Town of Bristol

Attached is a record of the email conversations I've had with Joe Kelly regarding posting a sign at the entrance of Sycamore Park. I'd like to talk to you about this at some point, soon, and will give you a call at the Town Garage to set a time. In the meantime I want you to have this information so you're up on the issue so far.

It was a pleasure speaking with you today about the Sycamore Park entrance on VT-116 in Bristol (44.097587, -73.094194). To assist patrons with locating the entrance, I recommend installation of a white on green street name sign.

1.500" Radius, 0.375" Border, White on Green;
 "Sycamore Park PVT" B 80% spacing;

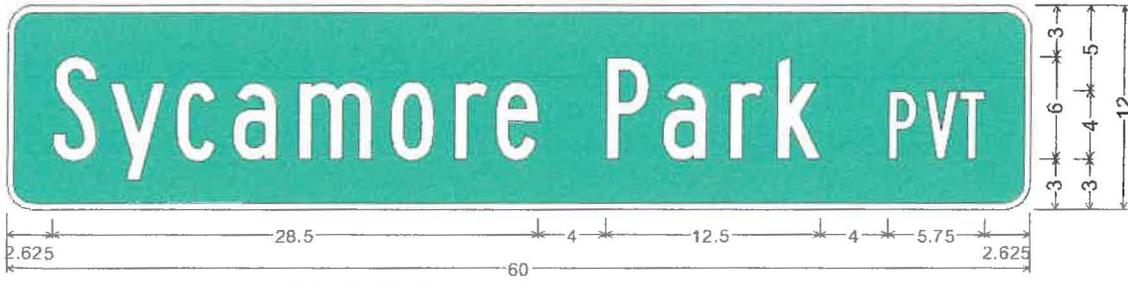
It appears from our records that the access is not a town highway but instead is a private road. In compliance with the Manual on Uniform Traffic Control Devices (MUTCD), the sign blade should be 12" in height with 6" text and also should have "PVT" on the sign, indicating it as a private road. Attached are two draft sign designs for your consideration. Since the sign will be in excess of 42" long, we recommend that it be installed on two posts. Either a double-sided sign on post top-mount brackets will be needed or two sign panels installed back to back on the same posts. Installation height should be at least 6 FT above the ground to bottom of sign.

Yes a S-1111 permit would be required, the Town of Bristol would be the applicant and they would be required to erect and maintain the sign per VTrans standards if they choose to do so, as it would be within the State Highway ROW.
